Accessibility Review Report – DA

Project Title: Sanctuary Point Library
944-947 Corner of Paradise Beach Road and Kerry Street,
Sanctuary Point

Report Version: 20286_ADR_DA_v1.1

- **Level 1 Research / Quiet Study**
 - Omission of 530mm latch side clearance.

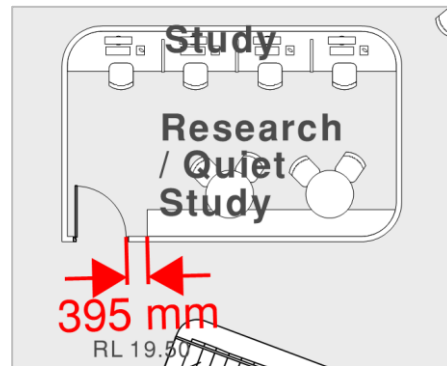
A number of doorways are not provided with sufficient circulation as prescribed in AS1428.1-2009. Examples of these doorways are outlined below:

- All doors are required to comply with clear space dimensions outlined in AS1428.1-2009 (refer to extracts from AS1428.1-2009 below for a front on approach to the doorway).

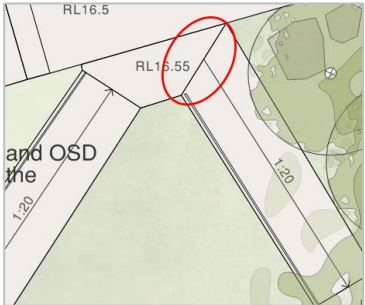
<ul style="list-style-type: none"> ○ Provide handrail + kerb rail details; ○ Landings to be on-grade and provided at the specified intervals; ○ Tactile indicators; and ○ Finishes details (required to confirm slip resistance). ● Stairway details including: <ul style="list-style-type: none"> ○ Stair design / opaque risers / no trip hazards; ○ Handrail details; ○ Stair nosing specification; Tactile indicators; and ○ Finishes details (required to confirm slip resistance). ● Walkways details including: <ul style="list-style-type: none"> ○ Gradient verification; ○ Landings at the specified intervals; ○ Walkway abutment to be confirmed; and ○ Walkways to be square to the landings – refer to compliance issue highlighted below:  <ul style="list-style-type: none"> ● Accessways must be free of any trip hazards (stepped edges >3mm or rolled edges >5mm). Details of the proposed external finishes including any grates or the like will need to be provided; ● Where a compliant scenario cannot be achieved it may be possible to pursue a Performance Solution to justify the provision of an accessible entrance as indicated by the blue arrow above. This is to be determined on a case-by-case basis and will

<p>require further development/discussion.</p> <ul style="list-style-type: none"> • Transitions at the allotment boundary require further attention to ensure a compliance scenario has been achieved – Further details to be provided; • Accessway from the accessible car spaces are to comply with AS1428.1-2009. • Ensure the principal pedestrian entrance (PPE) is compliant as prescribed by Cl. D3.2; and • Provide entrance door details to PPE. 	
--	---	--

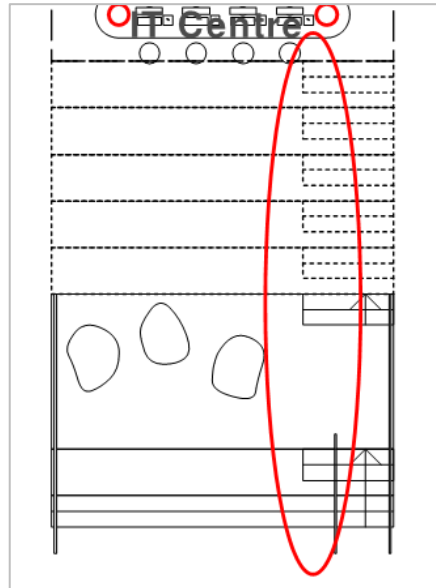
Handrails are not provided on either side of the stairway serving the internal tiered seating area – refer to markup below:

- Two handrails to be provided on either side of the stairway in accordance with AS1428.1-2009.
- Where a compliant scenario cannot be achieved it may be possible to pursue a Performance Solution to justify the provision of an accessible entrance as indicated by the blue arrow above. This is to be determined on a case-by-case basis and will require further development/discussion.

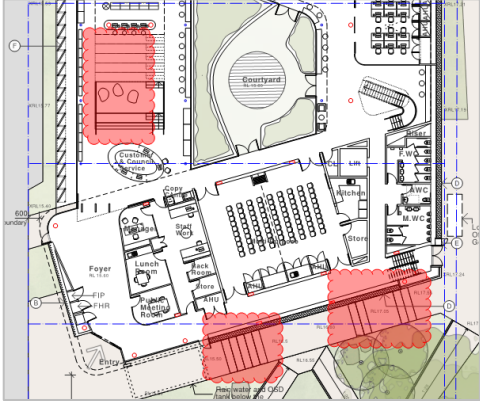
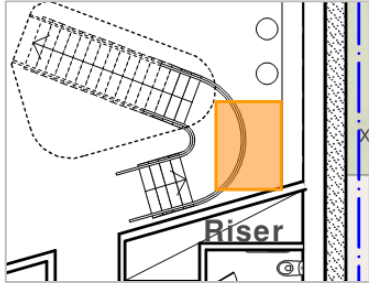
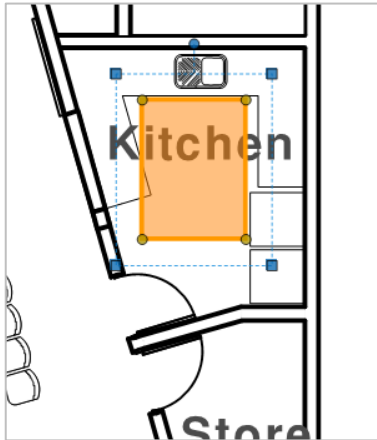
Note: Tiered seating and platforms are not stairways and therefore do not form part of this assessment. In addition it is noted that the external areas contain large platform areas which are excluded from this review – refer to markup below:

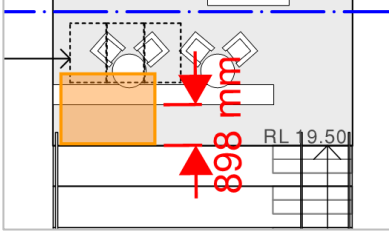
<ul style="list-style-type: none"> for a fire-isolated stairway, clause 11.1(f) and (g) of AS 1428.1; and 	N/A – no fire-isolated stairways are proposed	N/A
<p>Accessways must have—</p> <ul style="list-style-type: none"> passing spaces complying with AS 1428.1 at maximum 20 m intervals where a direct line of sight is not available turning spaces complying with AS 1428.1 at 20m intervals or within 2m of the termination of an accessway. 	<p><u>Compliance Departure –</u></p> <p>180° turning spaces (1,540mm X 2,070mm) are not provided within 2m of the termination of an accessway, as follows:</p> <ul style="list-style-type: none"> Ground Floor: <ul style="list-style-type: none"> Opposite internal stairway connecting to Level 1:  Ground Floor: <ul style="list-style-type: none"> Kitchen area:  Level 1: <ul style="list-style-type: none"> Youth Area 	CD/DD /PS

<p>Resolution –</p> <p>Either –</p> <ul style="list-style-type: none"> • Provide the prescribed turning and/or passing; or • Pursue a Performance Solution where compliance cannot be achieved. The requirements of the Performance Solution are determined on a case-by-case basis and will require further design development/discussion. 	
--	---	--

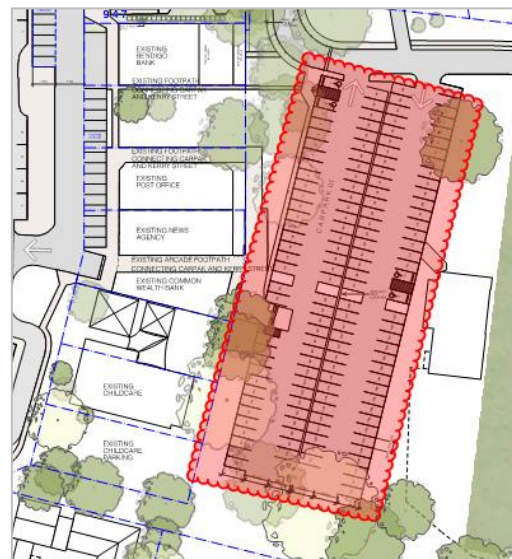
Additional provision of carparking is identified beyond the footprint of the proposed library scope. These areas have not been reviewed as part of this report – refer to markup below:

Scope clarification and further design details to be provided.

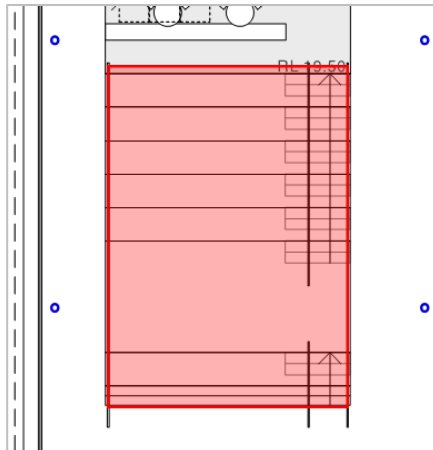
DtS Provision	Comment(s)/Recommendation(s)	Status
<p>Tactile ground surface indicators complying with sections 1 and 2 of AS/NZS 1428.4.1.:2009 must be provided to warn people who are blind or have a vision impairment that they are approaching –</p> <ul style="list-style-type: none"> • a stairway, other than a fire-isolated stairway; • an escalator/moving walk; • a ramp other than a fire-isolated ramp, step ramp, kerb ramp or swimming pool ramp; • in the absence of a suitable barrier an overhead obstruction less than 2 m; • and where an accessway meeting a vehicular way adjacent to any pedestrian entrance to a building. 	<p>TGSIs are to be provided to –</p> <ul style="list-style-type: none"> • a ramp other than a fire-isolated ramp, step ramp, kerb ramp or swimming pool ramp; • all stairway landings other than where handrails are continuous at mid landings and fire-isolated stairways; • any overhead obstruction less than 2m above floor level. • where an on-grade accessway meeting a vehicular way adjacent to any pedestrian entrance to a building. <p>TGSIs are yet to be indicated on the plans. Further details to be provided at the design development stage.</p> <p>TGSIs must comply with AS/NZS1428.4.1-2009.</p> <p>Note: The overhead obstruction (<2m) created by the internal stairway connecting to Level 1 is required to be provided with TGSIs or a suitable barrier as prescribed in the Standard.</p>	DD
